**WHITLEY COUNTY ADVISORY PLAN COMMISSION
STAFF REPORT**

24-W-SUBD-18 PRIMARY PLAT APPROVAL

"Zumbrun Minor Subdivision", 200 South, 2,000' east of SR 5

RE: Plat 24-W-SUBD-18 Zumbrun Minor Subdivision
Engineer Review

ZUMBRUN MINOR SUBDIVISION
IN THE SOUTHEAST QUARTER OF SECTION 15 & 16, TOWNSHIP 31 NORTH, RANGE 8 EAST,
RICHLAND TOWNSHIP, WHITLEY COUNTY, INDIANA

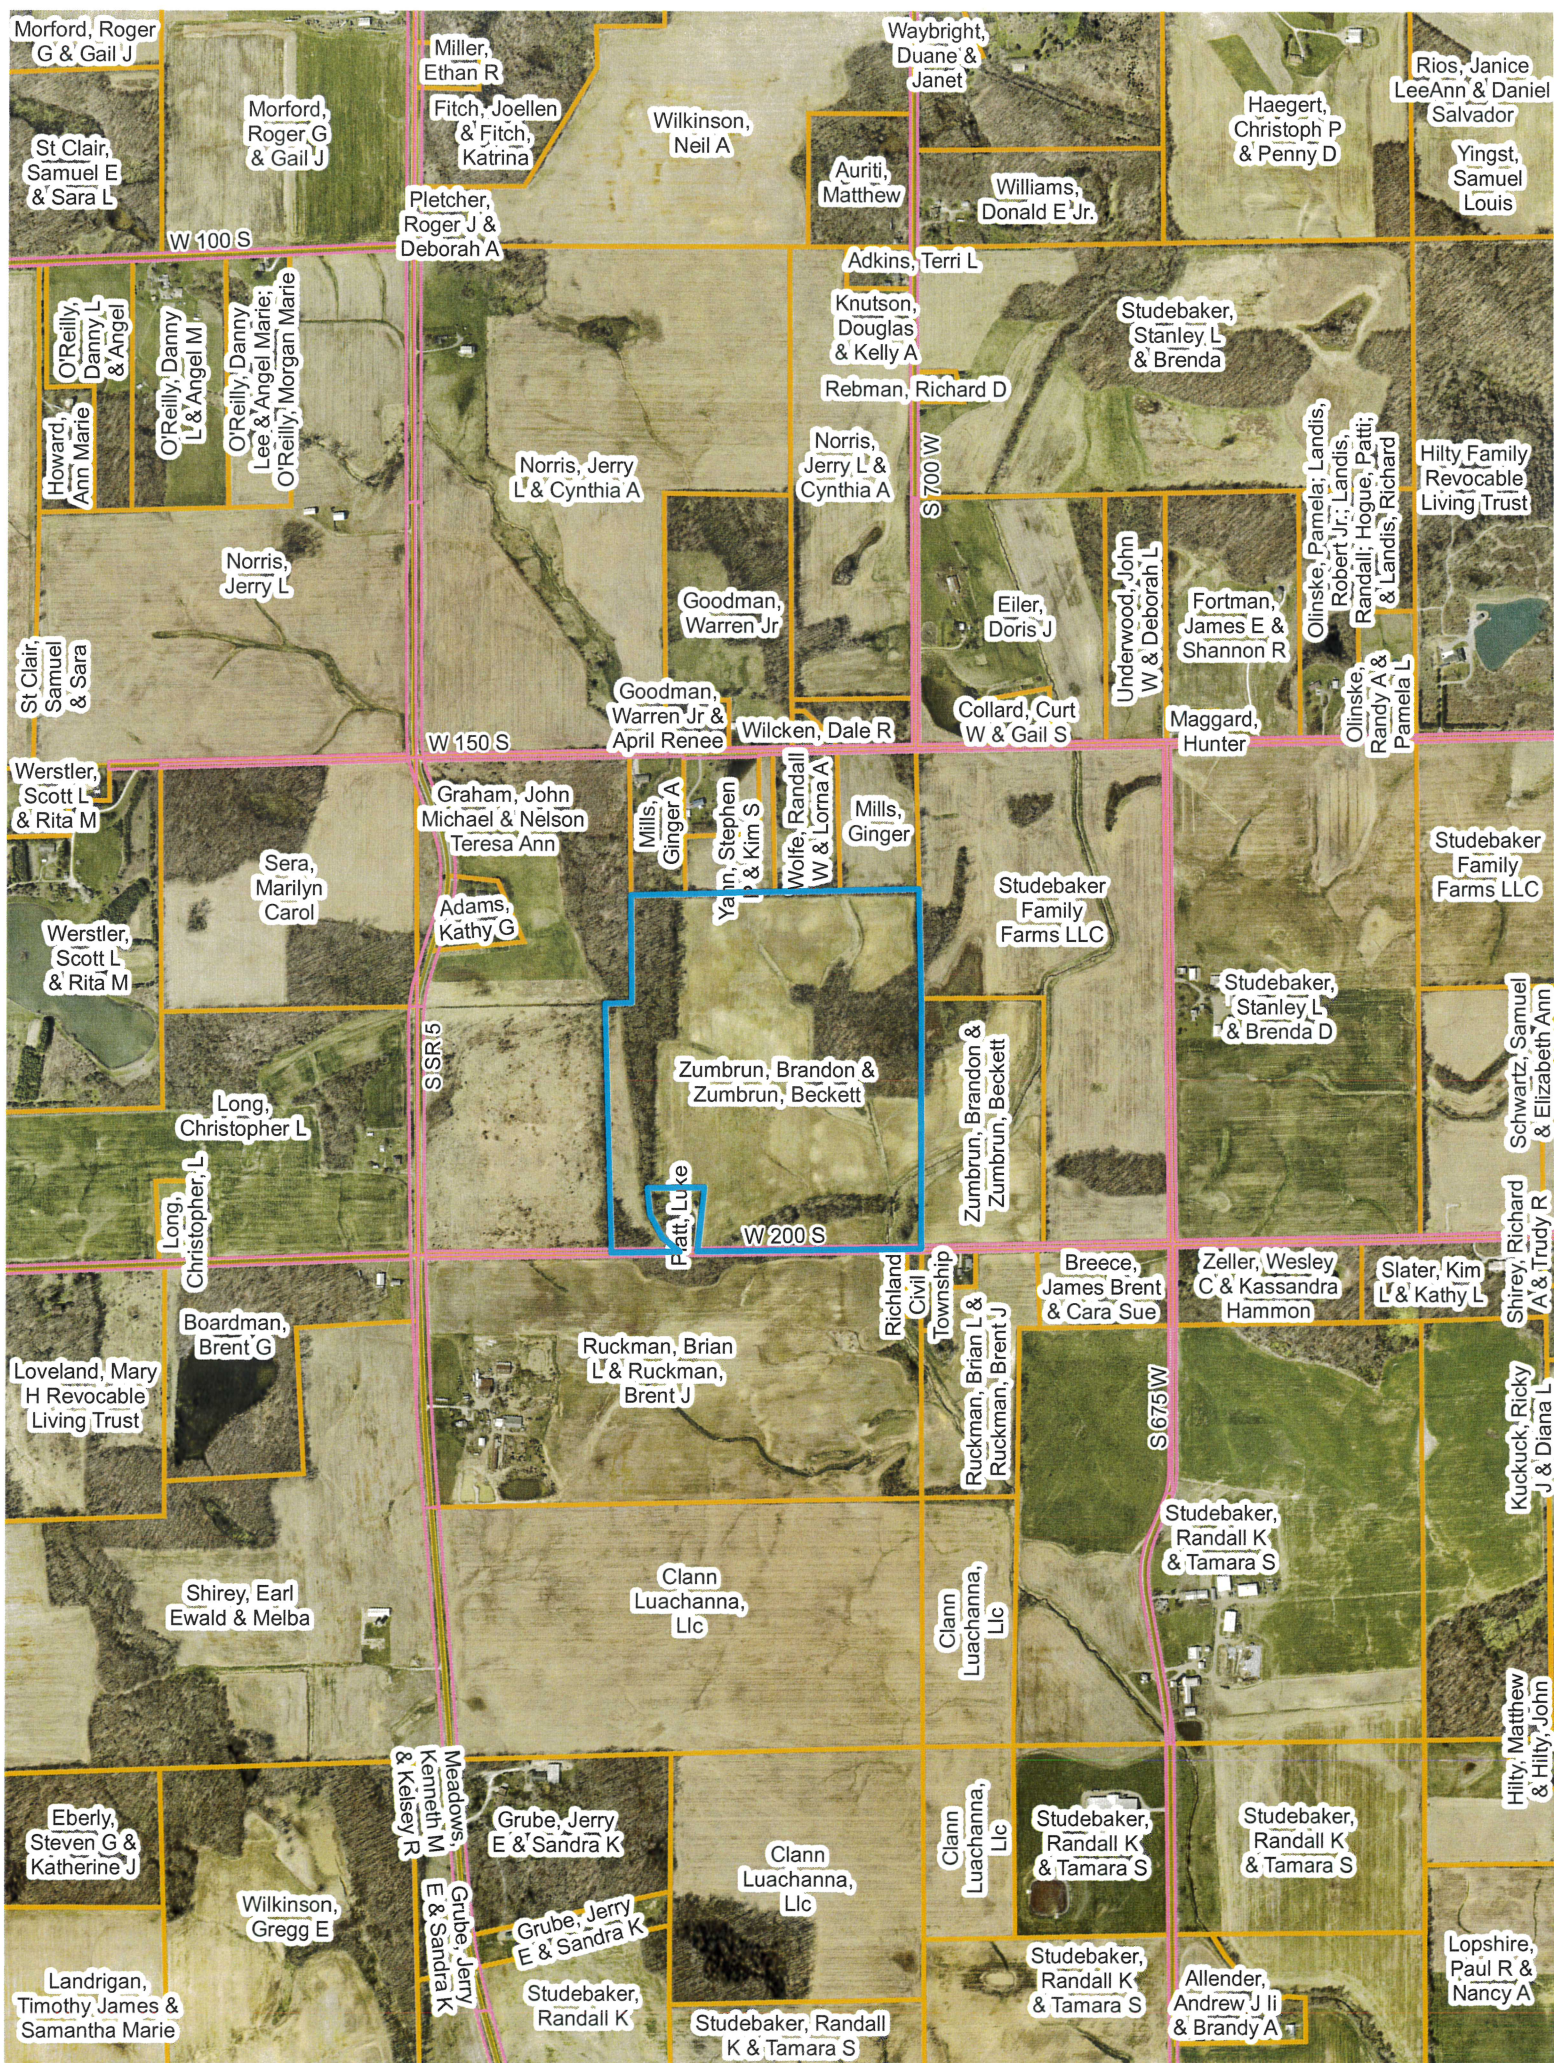
The County Engineer stated the stream on the north property line is not County regulated and would not require the 75' legal drain easement. Therefore, the easement can be removed from the plat. A driveway permit will be required from the Whitley County Highway Department, and the property does have sight-distance issues. He also recommends a note on the plat for a private drainage easement to allow maintainable drainage from the parcel to the north of the stream.

The Health Department noted that soil testing has not been completed for the property.

No right-of-way is shown to be dedicated on the submitted plat. 200 South is indicated to be a Local Road (60' right-of-way) on the Transportation Map of the 2022 Comprehensive Plan. Therefore, a 30' wide right-of-way for the county road would need to be dedicated.

Per the subdivision code standards, 10' drainage and/or utility easements will need to be shown on the perimeter of the lot, unless the Commission finds them to be unneeded.

- The eastern boundary of Lot # 1 is the Compton Ditch which is a regulated drain. Any development, including woody vegetation, structures and driveways, will need approval from the Whitley County Drainage Board to be placed within the 75 foot easement from the top of bank of the drain.
- The stream that runs along the northern portion of Lot #1 is not regulated by the Whitley County Drainage Board, and so does not have a 75 foot easement, it can be removed from the plat.
- The parcel to the north drains to the non-regulated stream along the northern portion Lot #1. I would recommend a note on the plat allowing for a private drainage easement to allow maintainable drainage from the parcel to the north to the stream.

- A drive permit will be required from the Whitley County Highway Department for each drive if not acquired already.
- There are sight distance issues on this site. A preliminary review suggests a drive is possible onto W 200 S, but a location should be selected that has an unrestricted view of 500 feet of roadway in both directions. Sight distance will be reassessed when a permit is filed.
- When the driveway permit is filed, depending on the location, the appropriate culvert size will be determined.
- Finally, at a minimum, the first ten feet of the driveway needs to fall away from the edge of pavement, for drainage purposes.

- 1. Secondary plat approval delegated to the Plan Commission staff.
- 2. Two septic sites per lot are to be determined and approved by the Health Department prior to issuance of a building permit for a primary structure.
- 3. 75’ drainage easement from the north stream be removed.
- 4. 10’ utility and drainage easements be denoted on the perimeter of the lot.
- 5. A 30’ wide right-of-way to be dedicated along 200 South, and the lot area adjusted.
- 6. Consider adding access easement for maintenance of the drains.
